SCHWEIZER SERVICE INFORMATION NOTICE

NOTICE NO. N-156

SUBJECT: FIELD REPAIR OR REMOVAL - TRIM TAB, MAIN ROTOR BLADE,
PN 269A1160 Series, 269A1185 Series, 269A1190 Series,
269B1145 Series

MODELS AFFECTED: All Model 269 Series Helicopters equipped with subject
Main Rotor Blades

Figure 1. Repair and removal of trim tab, main rotor blade

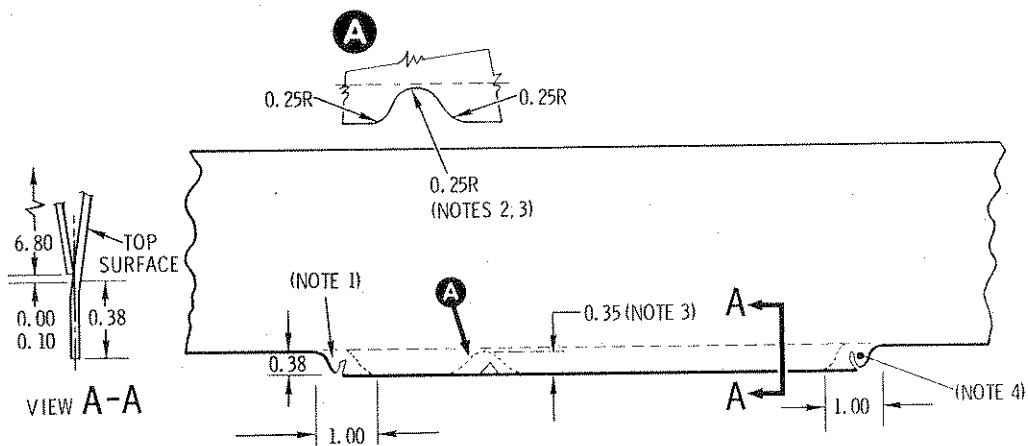
It is to be noted that instructions in the Basic HMI specify that the blade must be rejected, if specified damage limitations for the tab area are exceeded. In the interest of safety and economy, the procedures given in this Notice provide a broader clean up of the damaged trim tab area, which distributes stresses over a larger area to preclude cracking and permit continued use of the blade.

No minimum length of trim tab is required. In addition, the entire trim tab, or portion of the trim tab, may be removed if required. Main rotor blades with and without trim tabs are 100% interchangeable, individually and in ship sets.

- e. Remove damaged area of trim tab by making V-type cut with 45° sides joined by a 0.25-inch radius at the bottom of the V, as shown in Figure 1. Blend into trailing edge of the blade with a 0.25-inch radius as shown. Maximum V-cut depth is 0.35-inch; do not cut past trim tab area into main portion of blade.

- f. If damage occurs within 1-inch of either or both ends of trim tab, remove tab end(s) and restore contour as shown.
- g. If excessive damage requires full or partial removal of trim tab from blade, perform the following (no minimum length of trim tab is required):

2. Use metal cutting saw or equivalent to remove the 0.38-inch wide trim tab per dimensions shown in Figure 1, View A-A. Deburr edges in a SPANWISE direction only.

1. REMOVE DAMAGED END(S) IF THEY OCCUR WITHIN 1 INCH OF TAB ENDS.
2. 0.25 RADIUS CLEANUP. FINISH PER BASIC HMI.
3. MAXIMUM DEPTH OF REPAIR 0.35.
4. NO MINIMUM LENGTH OF TAB REQUIRED. IF DAMAGE OCCURS AT BOTH ENDS, IT IS PERMISSIBLE TO REMOVE AT BOTH ENDS.
5. ENTIRE TAB MAY BE REMOVED IF REQUIRED.
